IMPORTANT NOTICE

Modified procedures for InPower Solid State Contactors Models:

SSC10-100
SSC10-150
SSC10-200
LVD10 Series

InPower OM-101A
November 11, 2009

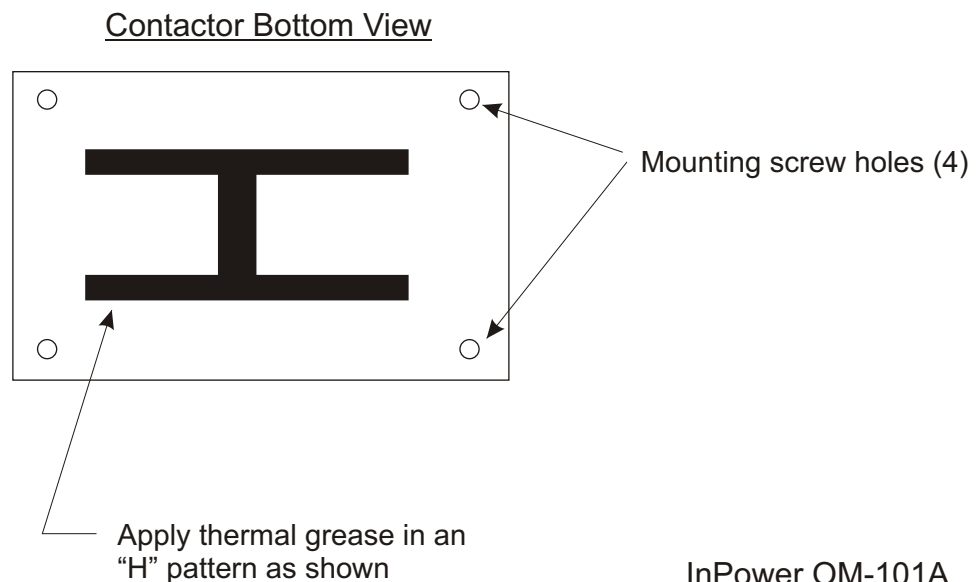
InPower has changed the method of mounting these contactors. The new procedure is to use thermal grease between the contactor bottom and the metal mounting surface. We will no longer use the thermal transfer pad. The new procedure is:

- Step 1 Apply the supplied thermal grease to the bottom surface of the contactor as shown in the diagram below.
- Step 2 Mount the contactor to the flat metal mounting surface using four #8-32 screws (not provided). Torque the screws to 5 inch pounds.
